PROJECT: MSynth-Pollvoiks-VCO	DATE: 13-Jan-23
BOARD: Control	TIME: 14:43:55
BY: jvdem	REV: 1.1

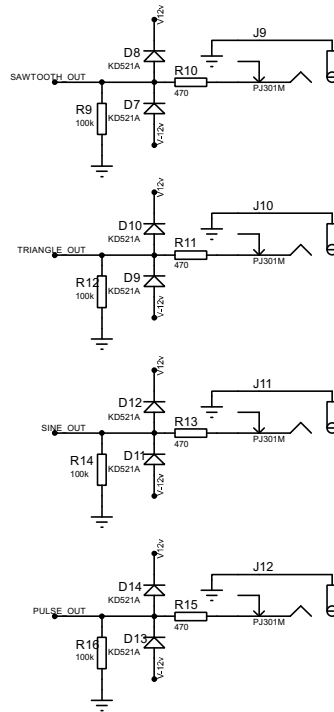
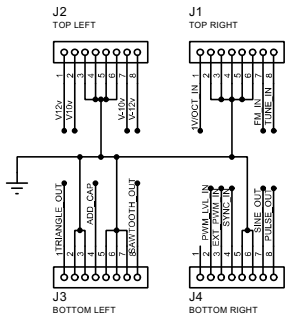
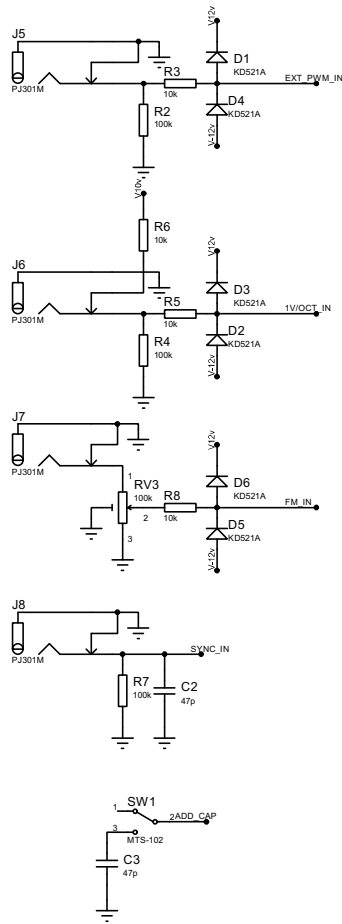
Change log:	v1.0	v1.1
RV1	incorrect pin 1 and 3 assignment	pins 1 and 3 swapped
